DAUPHIN SQUARE COMMERCIAL PARK
SUBDIVISION (AMENDED PLAT), RESUBDIVISION OF
LOTS 20, 21, AND 22

APPLICATION NUMBER 17 DATE March 20, 2003

REQUEST Subdivision

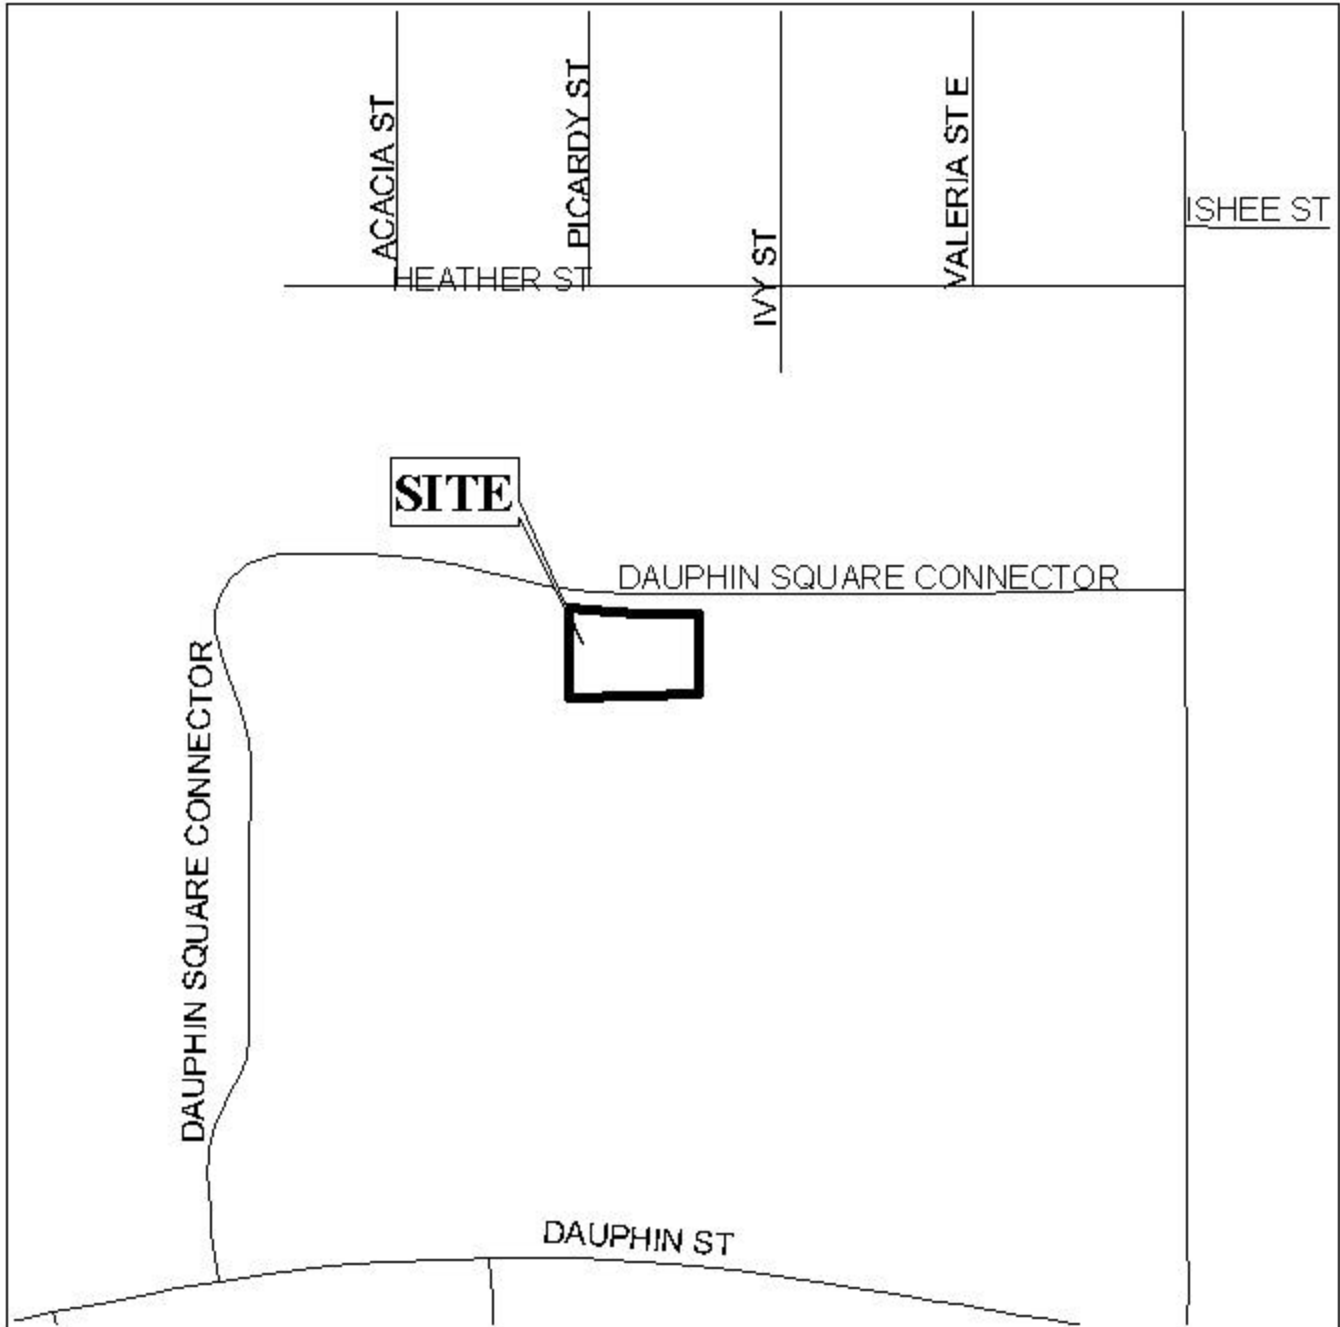
Engineering Comments: Must comply with all stormwater and flood control ordinances. Any work performed in the right-of-way will require a right-of-way permit.

Traffic Engineering Comments: Driveway numbers, size, location and design to be approved by Traffic Engineering and conform to AASHTO standards.

As a means of access management, the placement of a note on the final plat stating that the site is limited to one curb cut to Dauphin Square Connector, with the size, location and design to be approved by Traffic Engineering, should be required

The plat meets the minimum requirements of the Subdivision Regulations and is recommended for Tentative Approval subject to the following condition: 1) the placement of a note on the final plat stating that the site is limited to one curb cut to Dauphin Square Connector, with the size, location and design to be approved by Traffic Engineering.
